ALERT SERVICE BULLETIN

NO. 430-02-26

MODEL AFFECTED: 430

SUBJECT: WHEEL GEAR HYDRAULIC TUBE ASSEMBLY
P/N 430-080-459-101 AND WHEEL BRAKE
HYDRAULIC TUBE ASSEMBLY 430-080-460-101
AND 430-080-467-101 REPLACEMENT OF

Figure 2
Cargo hook release cable clamping modifications

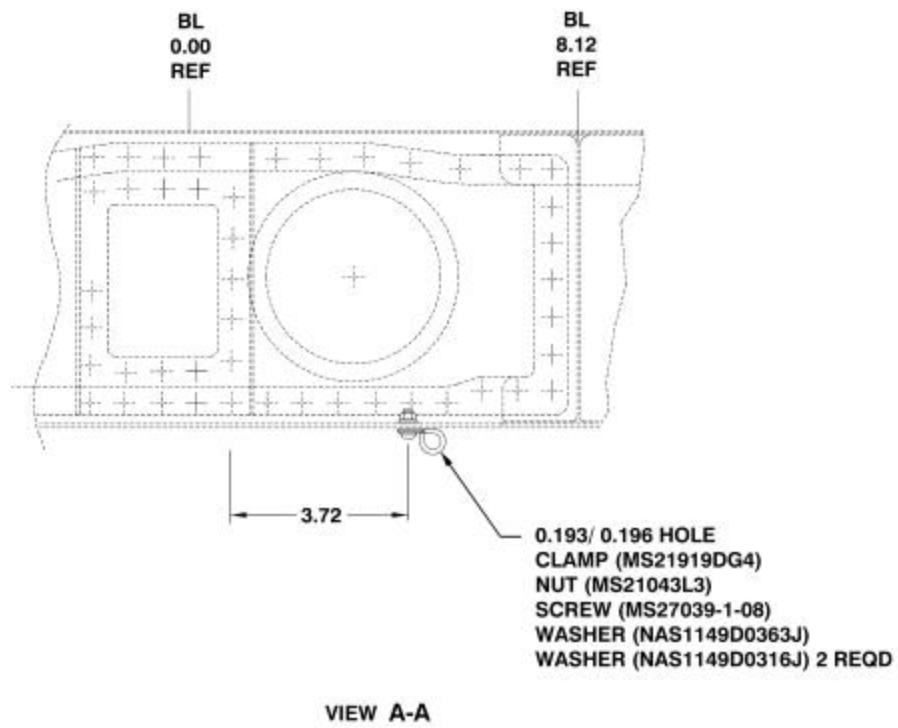
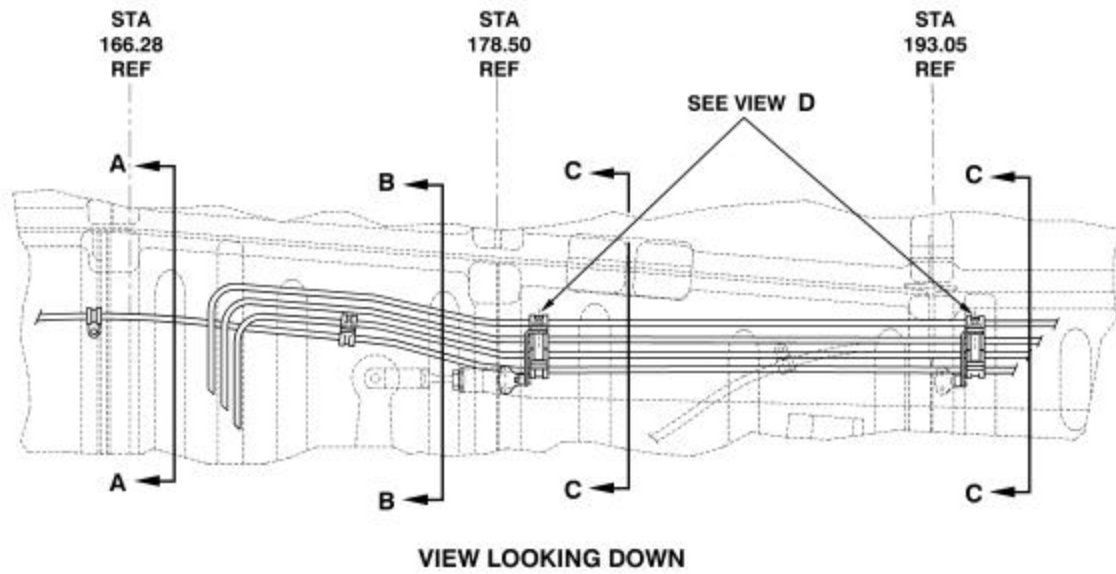
10. If cargo hook kit P/N 430-706-905-101 or -105 is installed you will need to modify the clamping for the cargo hook release cable P/N 222-320-925-103 as per figure 1 and 2.

In addition if the cargo hook kit P/N 430-706-905-101 or -105 is installed the mechanical release cable P/N 222-320-925-103 will require additional clamping with the new tubes.
